MIAMIBEACH PLANNING DEPARTMENT Staff Report & Recommendation

Design Review Board

DRB19-0430 SUBIECT: 1311 15th Terrace

An application has been filed requesting Design Review Approval for the construction of a new residential townhouse development to replace an existing building including one or more waivers and variances to reduce both side and sum of the setback requirements.

Portion of the 1925 Plat of ReSubdivision of Blocks 67 and 79 (subject property Lot 8 and the east ½ of Lot 9, Block 67-A)

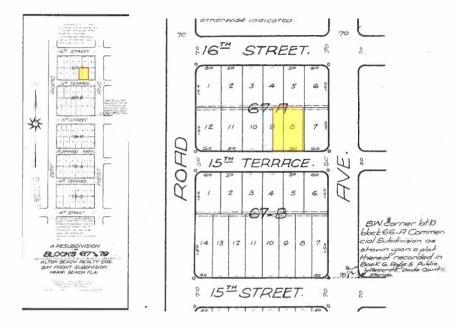
The subject property is a rectangular interior site on a block that was historically platted as a series of twelve rectangular blocks with a standard lot width of 50'-0" for interior lots and 60'-

0" for the four corner lots. The site currently contains a two-story structure built in 1925 as a private residence. According to the City's building card, the residence was built on lot 8 and half of lot 9, within block 67-A.
